# PAVING SERVICES AT NORTON APARTMENTS AMENDMENT #2

## A. ADDITION TO SCOPE OF WORK:

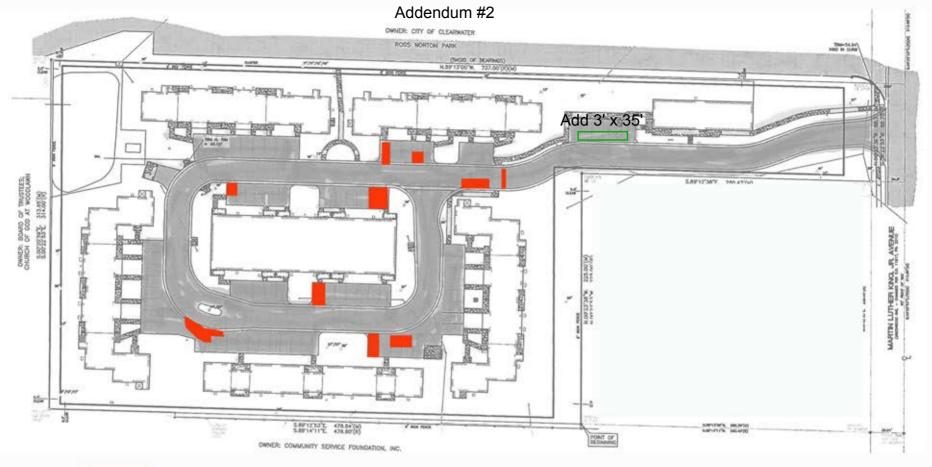
See attached map for 3' x 35' section highlighted in green.

REFER TO SCOPE OF WORK TACK COAT REPAIRS. RED AREAS ARE NEAR THE FOL-LOWING LOCATIONS: PARKING SPOTS 203, 201, 701-702, 706, 506, 710, 502, 501, 601 AND (2) SPEED BUMPS. LOCATIONS ARE ALSO MARKED ONSITE.
